# **GROUNDWATER FLOW AND TRANSPORT MODEL EVALUATION AND DEVELOPMENT**

**TOOELE ARMY DEPOT  
TOOELE, UTAH**

**Contract No. DACW05-00-D-0010  
Task Order No. 7**

**GROUNDWATER FLOW AND TRANSPORT MODEL EVALUATION AND  
DEVELOPMENT  
TOOELE ARMY DEPOT, TOOELE, UTAH**

**FIGURE 3-6**  
**Head Versus Time in Bedrock Block**  
**at Monitoring Wells Very Near E-05**

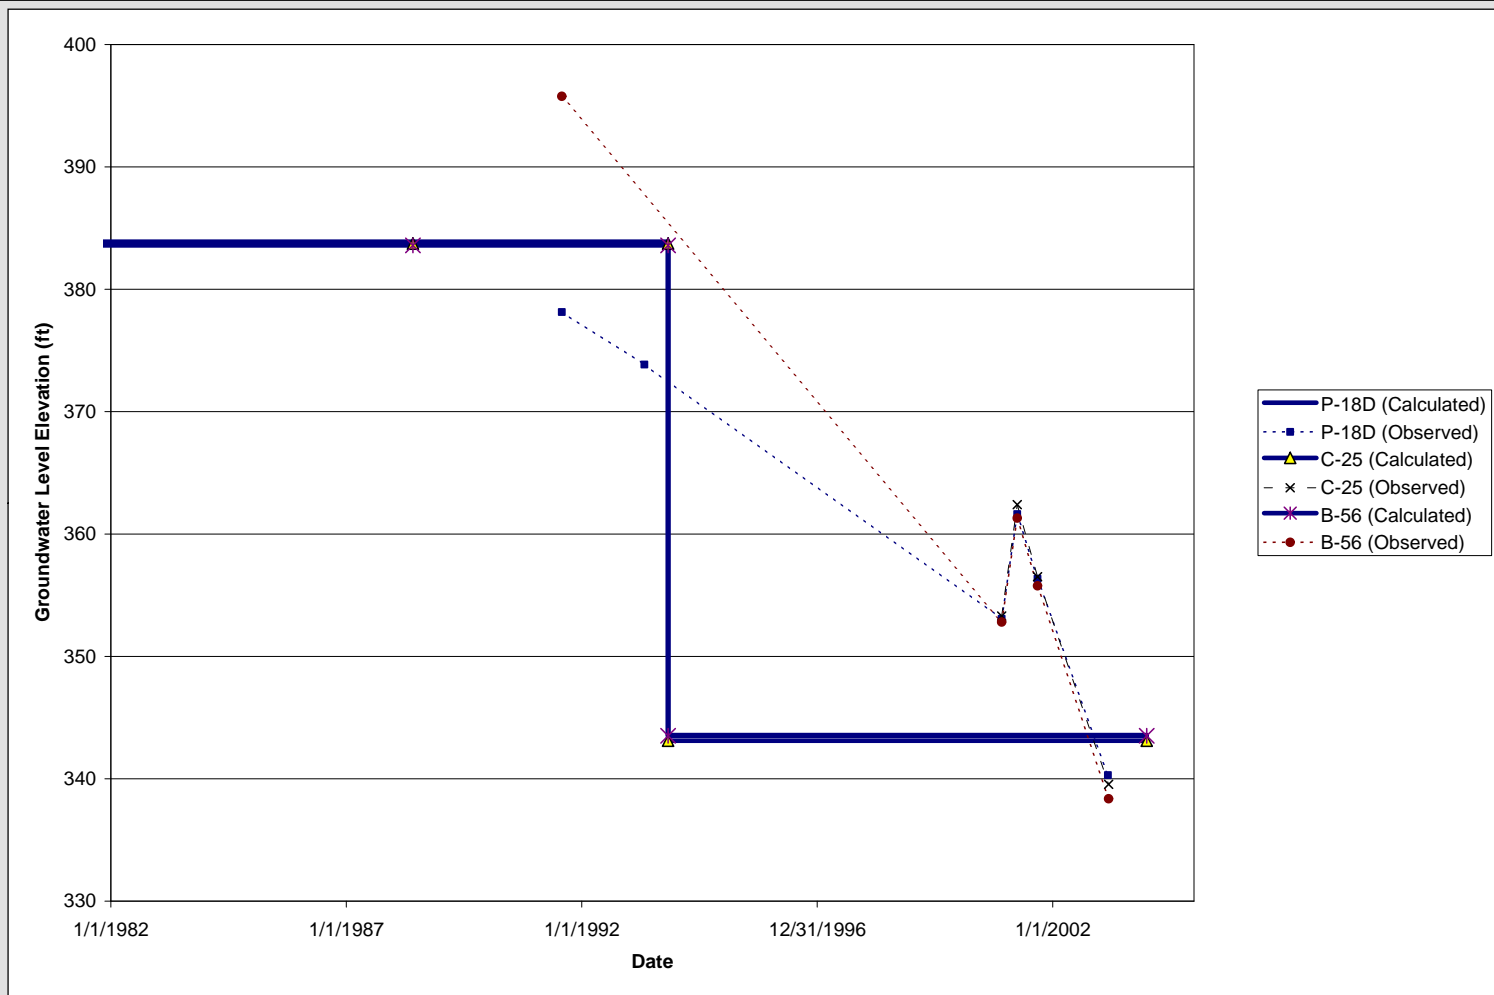
- Very near E-05: the match to currently observed drawdown is reasonable (Figure 3-6).

**FIGURE 3-7**  
**Head Versus Time in Bedrock Block**  
**at Monitoring Wells Very Near E-05 and E-08**

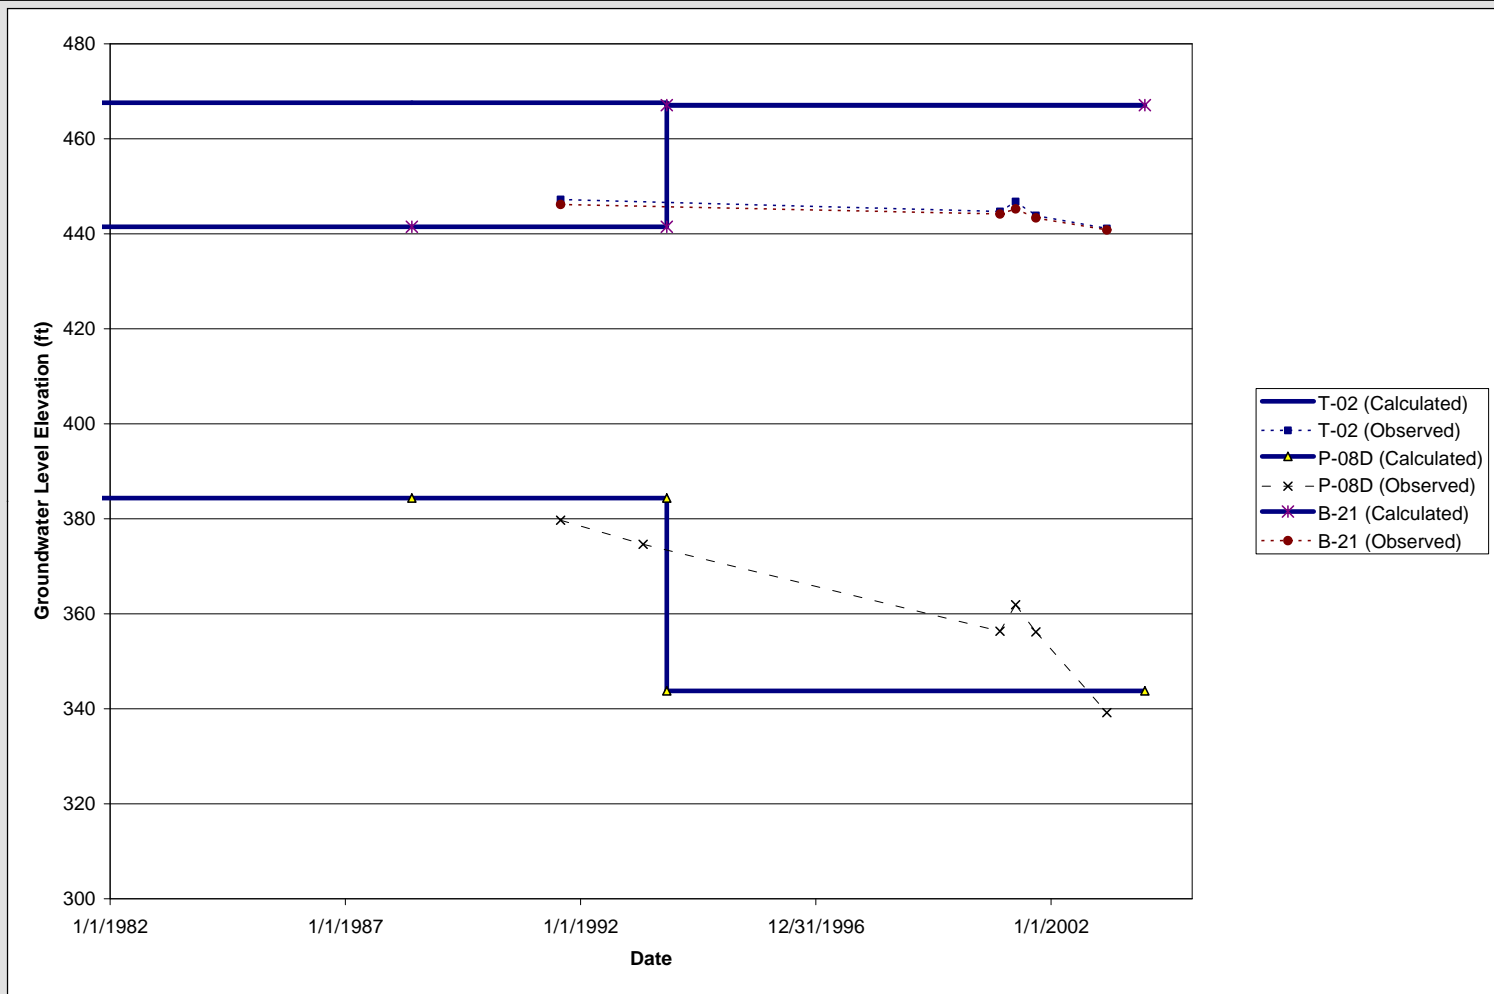
- Near E-08 and E-05: the match to currently observed drawdown is reasonable inside the block, but poor near the bounding model fault (Figure 3-7).
- Far from E-05, E-08, E-09, E-10, E-04: the match to currently observed drawdown is reasonable inside the block (Figure 3-8).
- Vertical extent of the capture zone may be over predicted because the model simulates less vertical head difference than observed (Figure 3-9).
- Horizontal extent of capture zone inside the block cannot be evaluated because of the paucity of pre-pumping water level data.

**FIGURE 3-10**  
**Head Versus Time North of Bedrock**  
**Block at Monitoring Wells Near E-02**

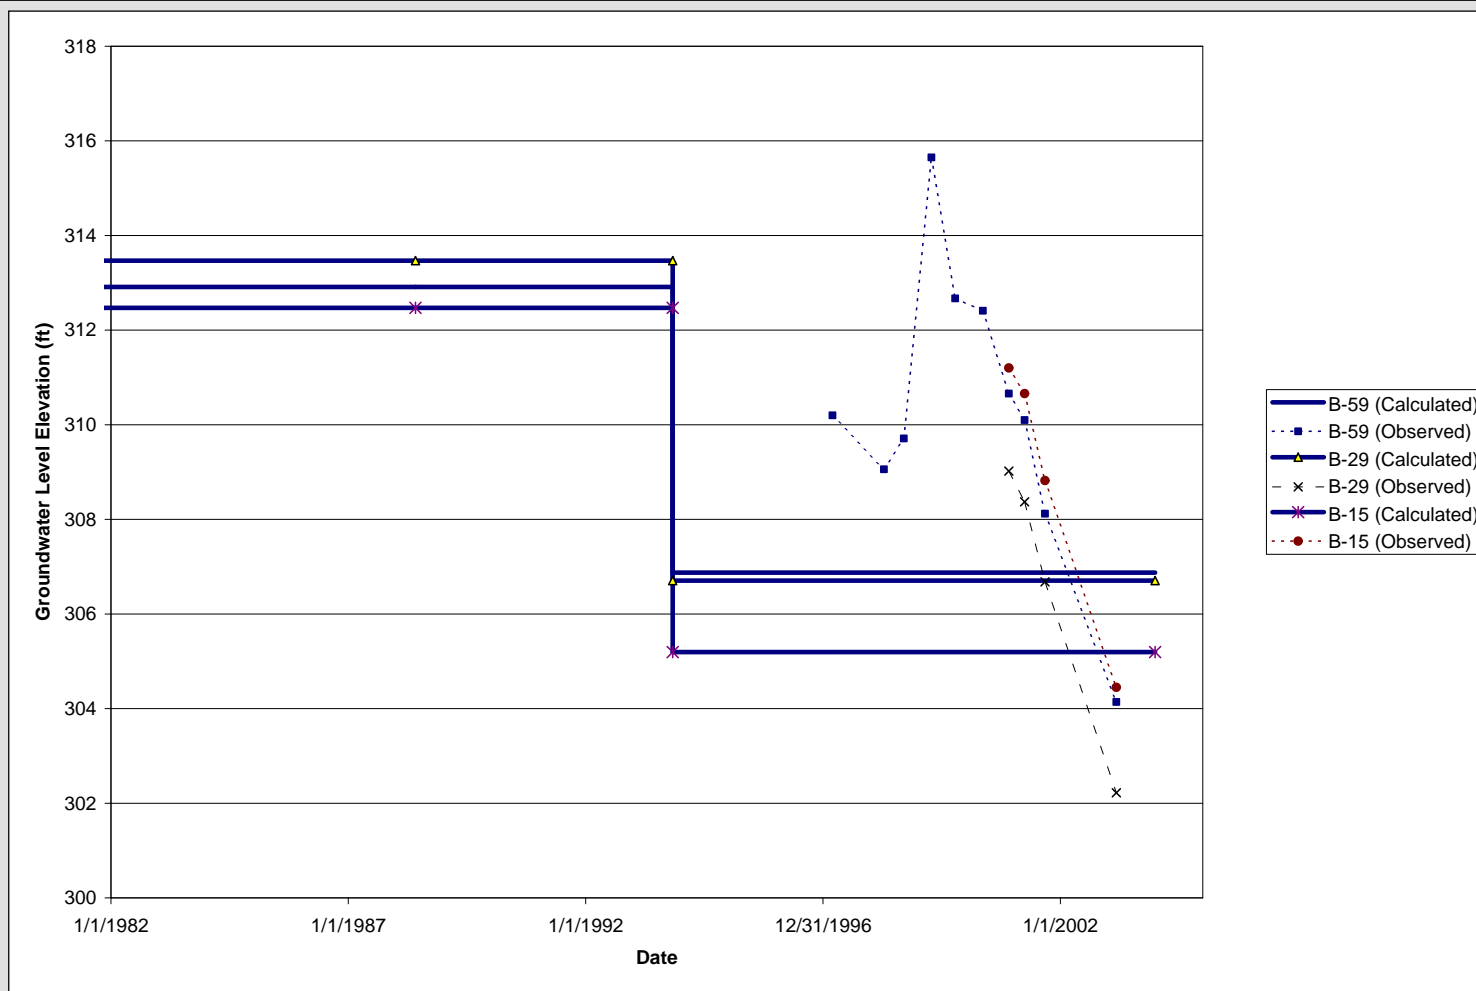
- Near E-02-1/E-02-2: the model under predicts currently observed drawdown by a factor of about two (actual amount is not clear due to lack of pre-pumping data) (Figure 3-10).

**FIGURE 3-11**  
**Head Versus Time North of Bedrock Block**  
**at Monitoring Wells Far from E-02, E-13, and E-14**

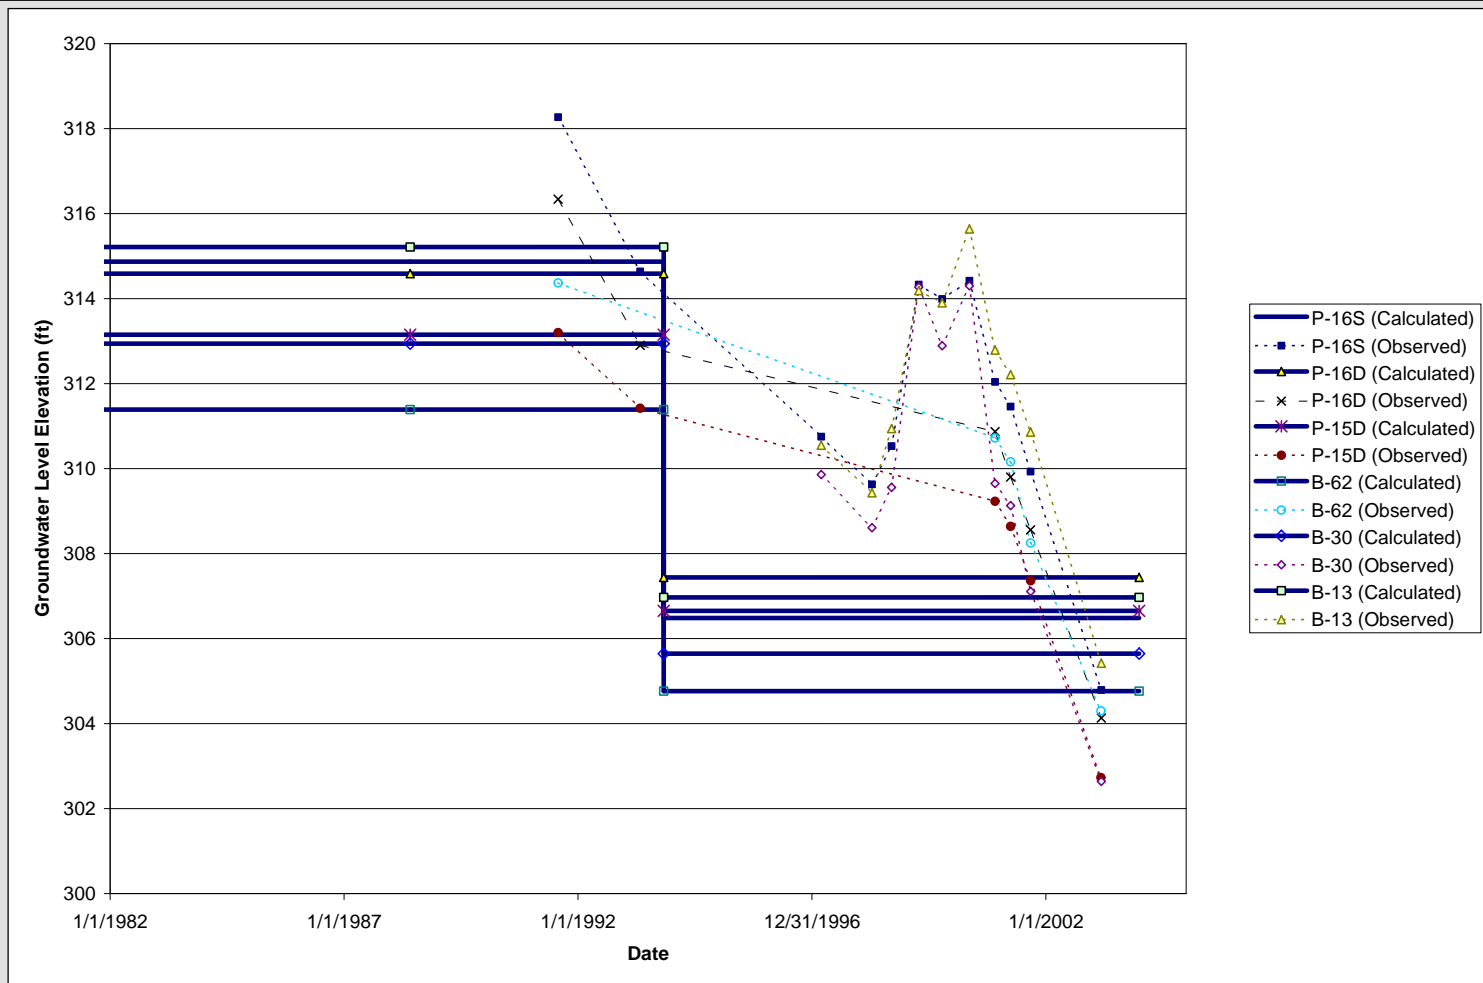
- Far from E-02-1/E-02-2, E-13 and E-14: the model generally under predicts drawdown, and a significant period of time during which water levels recovered is not represented. During this period, capture may have been lost, but the model assumes/simulates continual capture (Figure 3-11).

**FIGURE 3-12**  
**Head Versus Time North of Bedrock Block**  
**at Monitoring Wells Near I-02 and I-03**

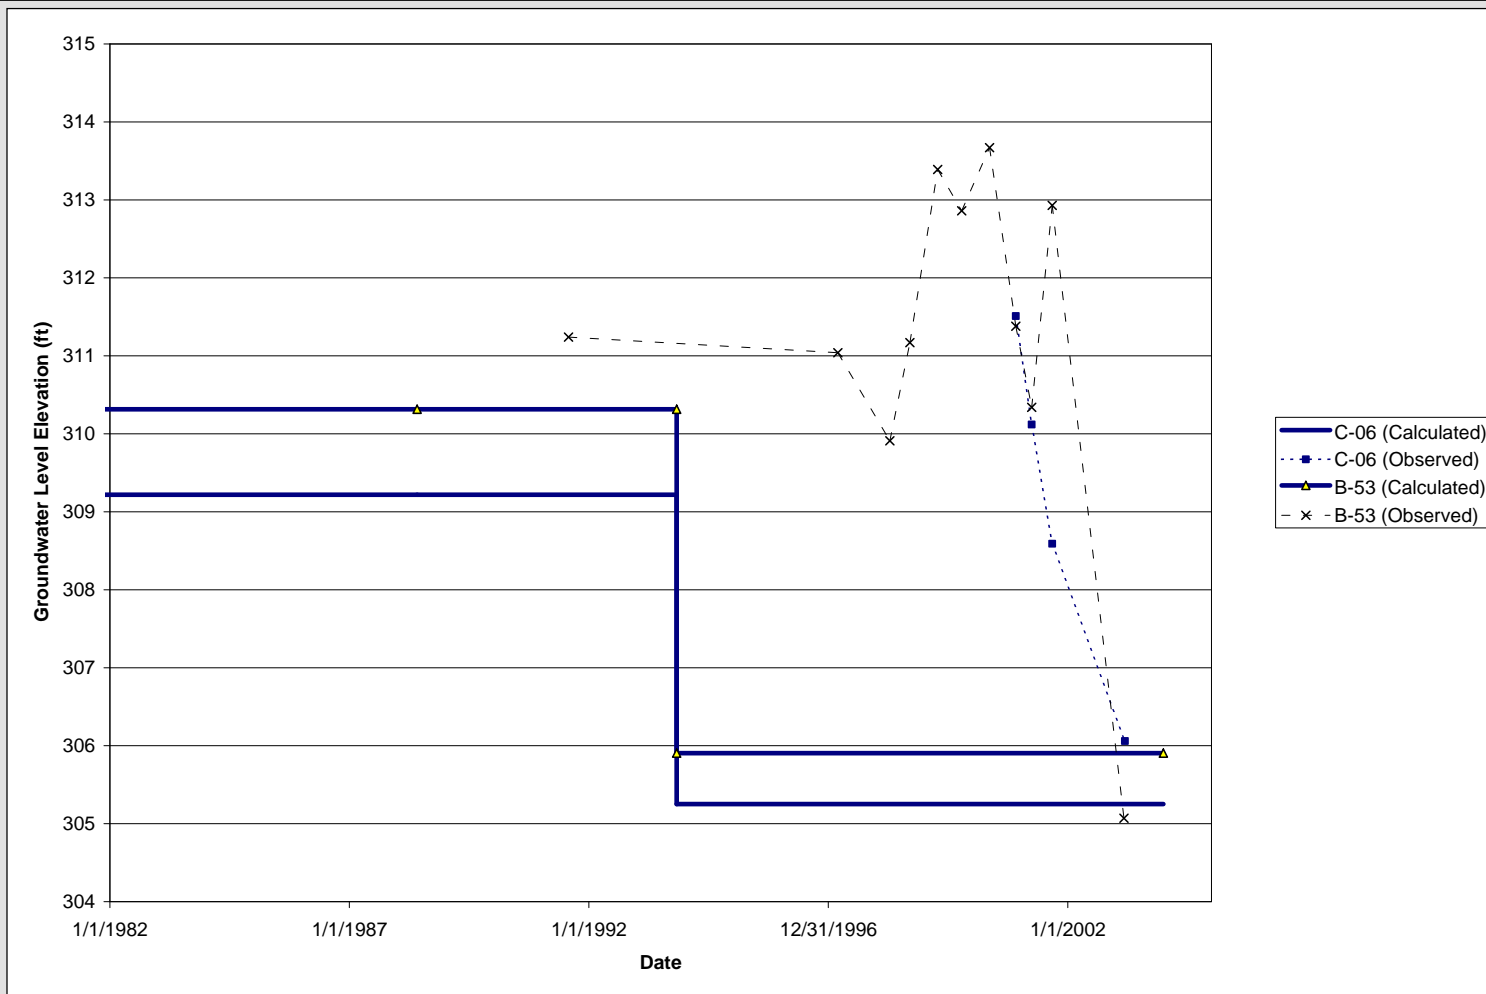
- Near to very near I-2 and I-3: the model simulates the currently observed drawdown reasonably well. However, there is a significant period of time when draw up is observed rather than drawdown (due to injection or shutdown of extraction wells). The predicted zone of influence of injection wells is not accurate, and predicted capture zone of extraction wells are not realistic in this area during the period of draw up (Figure 3-12).

**FIGURE 3-13**  
**Head Versus Time North of Bedrock Block**  
**at Monitoring Wells Far from I-01 and I-02**

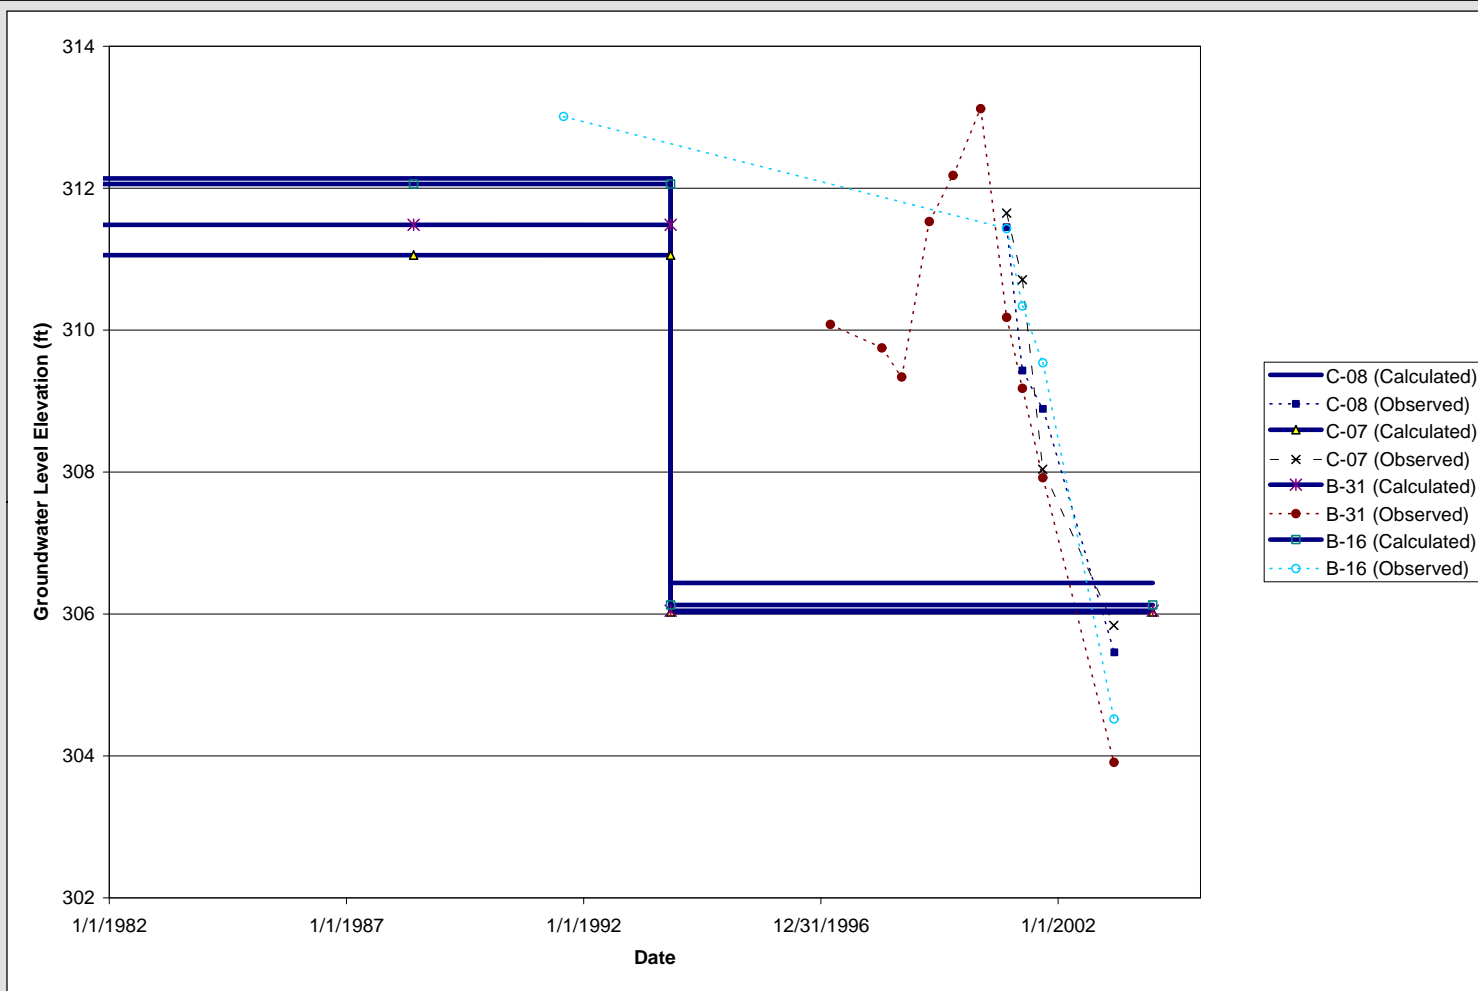
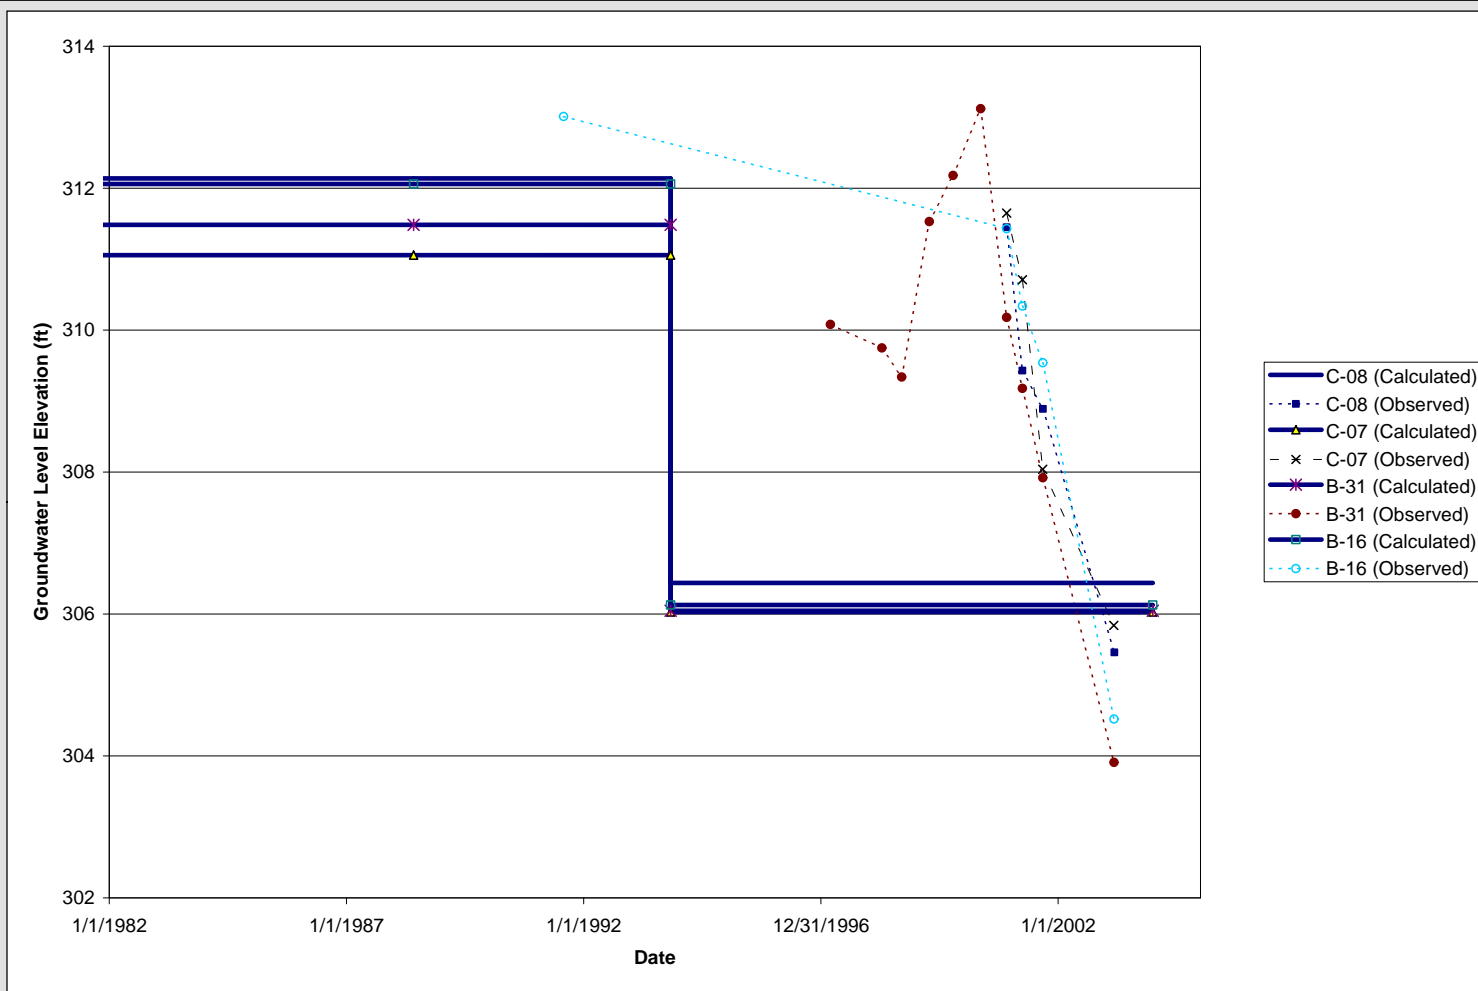
- Far from I-1 and I-2: the model under predicts currently observed drawdown. There is a significant period of time where drawup is observed rather than drawdown (due to injection or shutdown of extraction wells). The predicted zone of influence of injection wells is not accurate, and predicted capture zone of extraction wells are not realistic, in this area during the period of draw up (Figure 3-13).
